Request for Quotation

RFQ NUMBER
 DEP14651

DEP14651
Glen White Air Shafts

DEP14651
Glen White Air Shafts
Addendum # 1

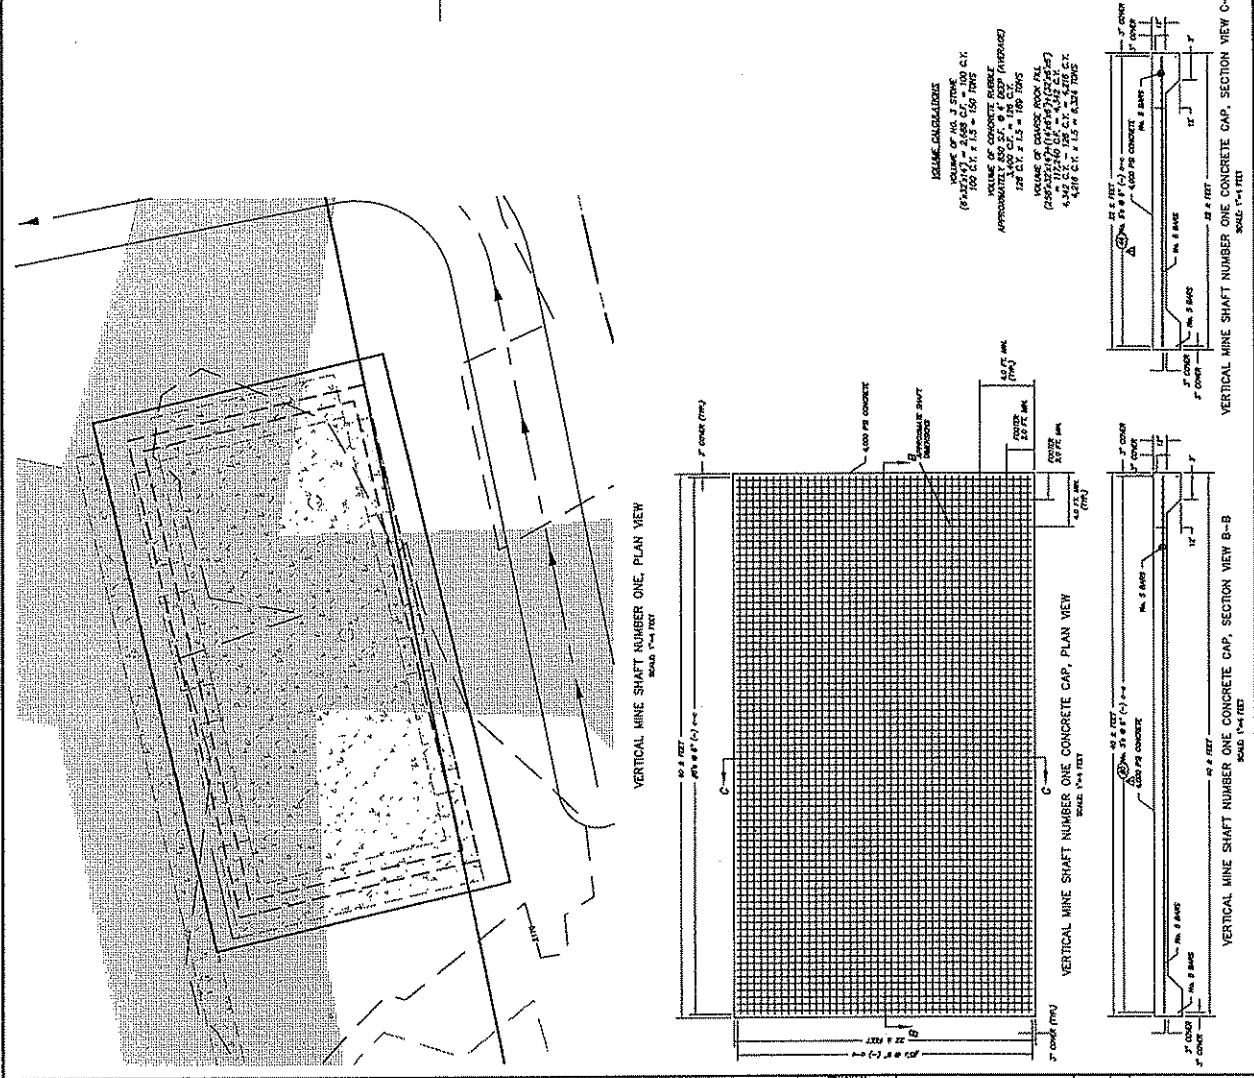
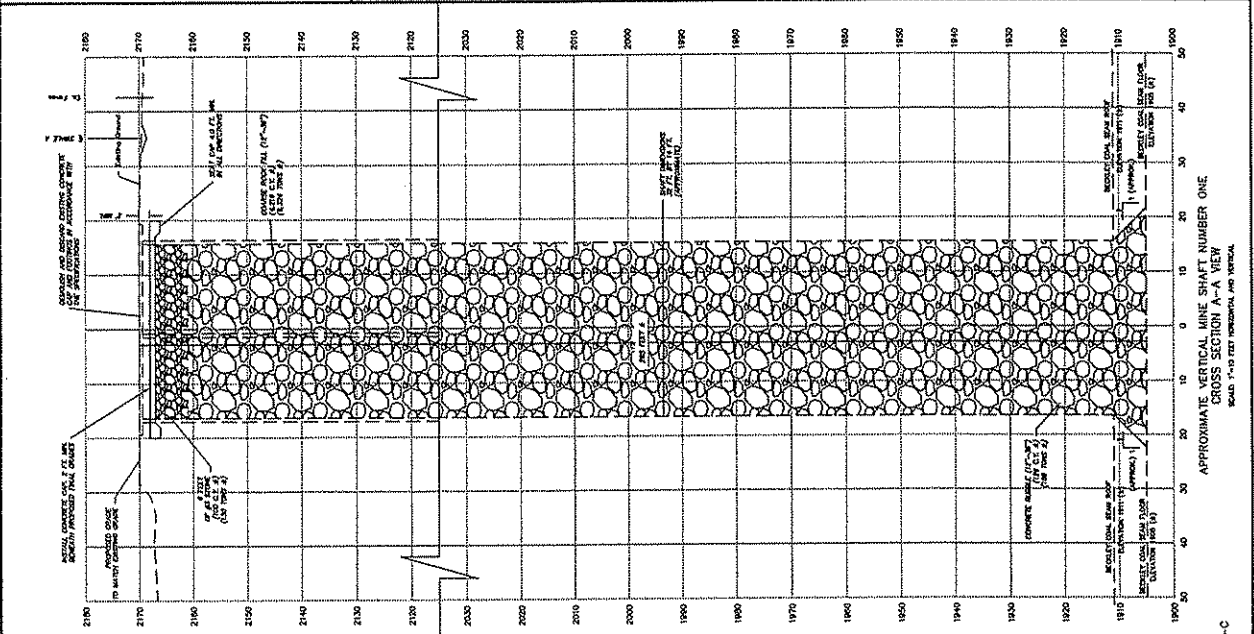
Item 2: On plan sheets 3 & 5, under "Section View B-B" and "Section View C-C", the plan note reads, "40 No. 5's @ 6" c-c", and "22 No. 5's @ 6" c-c", respectively. The note should read "80 No. 5's @ 6" c-c", and "44 No. 5's @ 6" c-c". Revised sheets 3 & 5 are included in this addendum.
